FROM: Planning and Development Services Department

DATE: March 28, 2017

SUBJECT: Petition DB-15-114 SUB. EDA Engineers-surveyors-planners, Inc., agent for New Generation Home Builders Inc. Design plat review for a subdivision of Blues Creek Unit 5, containing 44 lots on 36.7 acres. Zoned: PD for single-family residential. Located in the 7000-7800 Block of NW 58th Street.

**Map 3.
Blues Creek Subdivision.**

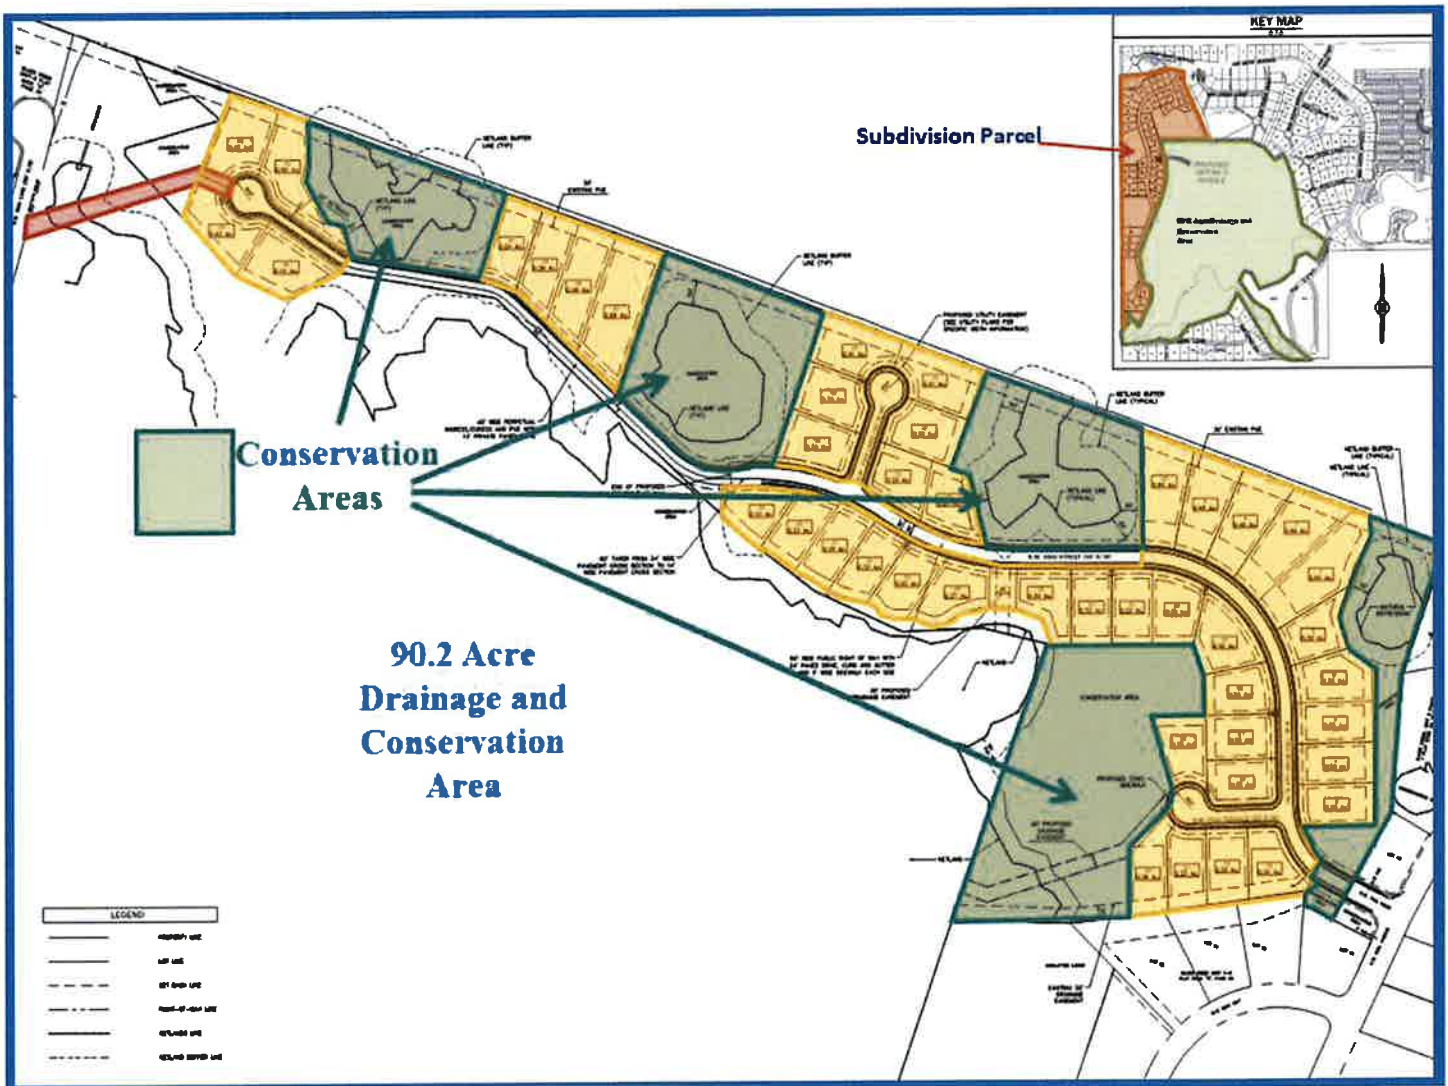
The PD requires that all lots shall be designed outside the 90-acre area and shall maintain a 35-foot buffer from all wetlands. The lots proposed within the subdivision are clearly out of the 90-acre area and is in general compliance with this condition; there are some instances where distances must be provided to demonstrate compliance.

The roadways provided within the subdivision are mostly public and are constructed at 50 feet wide with sidewalks on both sides. No portion of the public roadway system is within the 35-foot wetland buffer limit. The six lots located at the south end of the subdivision will be served by a private driveway with a minimum of 40 feet wide with sidewalk on one side. In some instances, this private road encroaches into the 35-foot wetland setback but only to the extent possible to facilitate access to the limited number of lots allowed along that private road; the PD ordinance allows this flexibility.

The design plat shall show a 35-foot line around all wetlands to clearly establish that all lots are in compliance with the 35-foot buffer established by the PD.

The applicant shall demonstrate on the plat, the limits of roadway encroachment into nearby wetlands including the dimensions of such encroachments.

**Map 4.
Blues Creek Subdivision Typical Roadway Cross Section.**

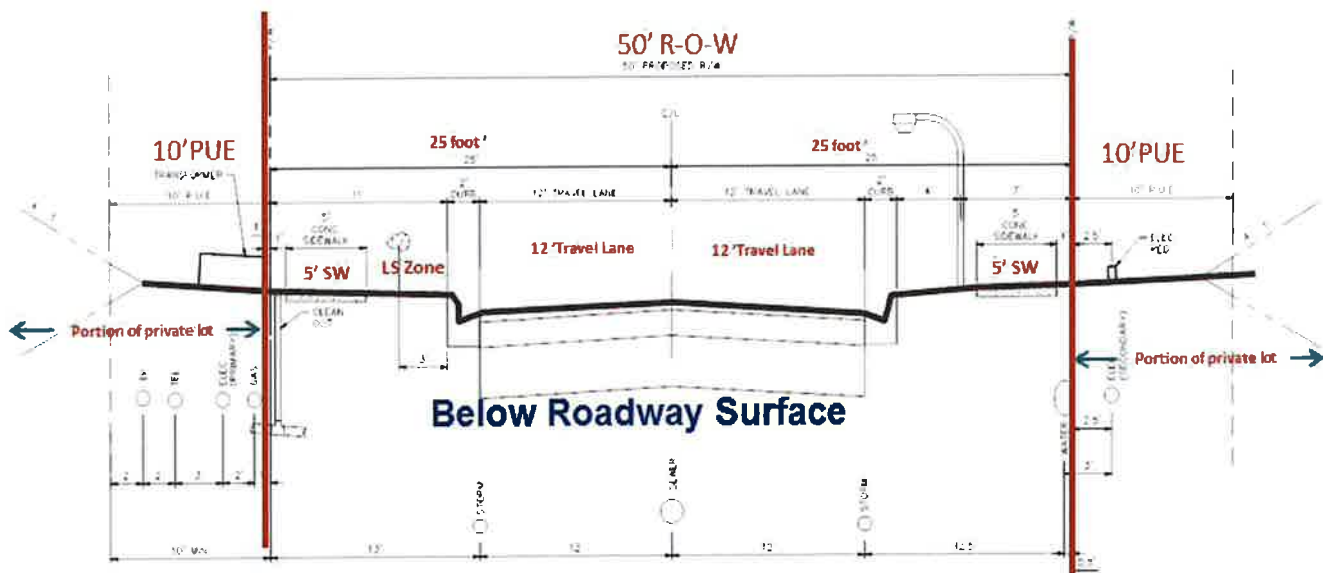
Streets are generally required to have a minimum width to provide for adequate traffic volume, street tree, public convenience, safety, and to adequately serve the uses intended. The require width varies depending on the roadway type but typically, local streets are required to have a right-of-way width of 50-feet, 24 feet of paved driving lane, plus additional easements to accommodate utilities. The proposed subdivision has provided a design cross-section, Map 4, indicating compliance with the requirements. The applicant is proposing a travel lane width of 10 feet which has been approved by Public Works.

Except as modified by the PD ordinance and through this petition, all roadways shall be constructed to the standards as specified in the Public Works Design Manual.

**Map 5.
Blues Creek Subdivision Typical Private Roadway Cross Section.**

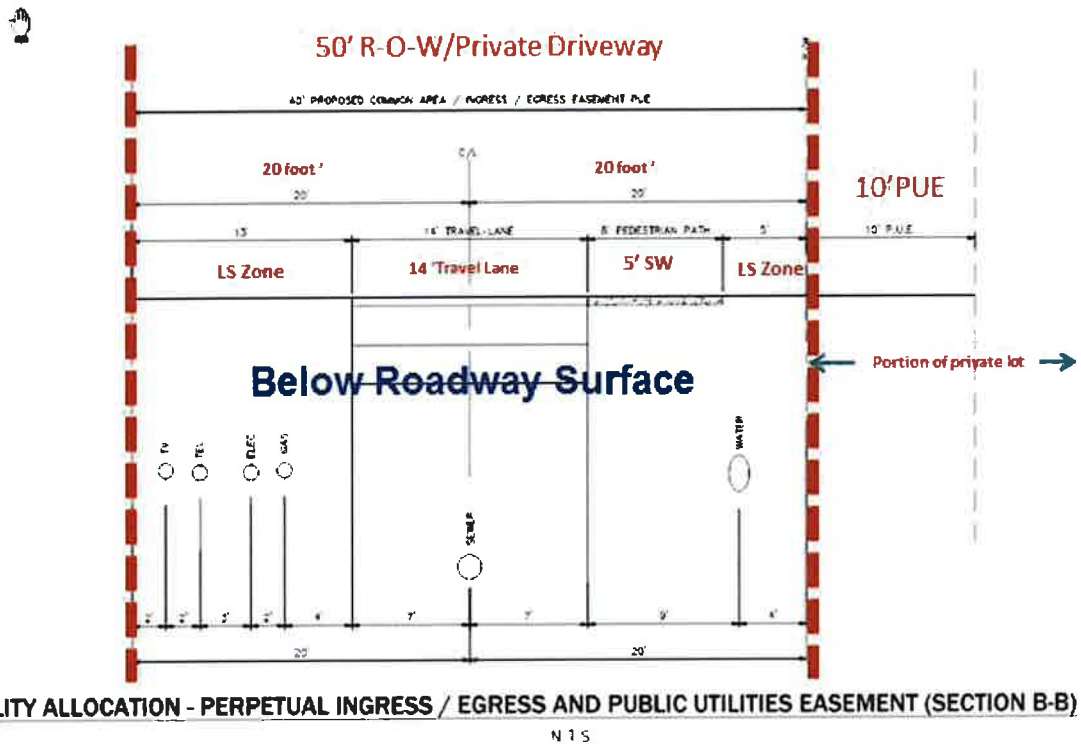
The roadway systems within the subdivision are intended to be constructed as public streets. However, due to environmental concerns the PD ordinance allows a portion of the roadway system to be constructed as a private road with a minimum width of 40 feet. Notwithstanding, all roadway construction shall be in accordance with the standards as specified in the Public Works Design Manual.

At the sole expense of the developer lighting shall provide in all the private roadways similar to standards for public street lighting requirements.
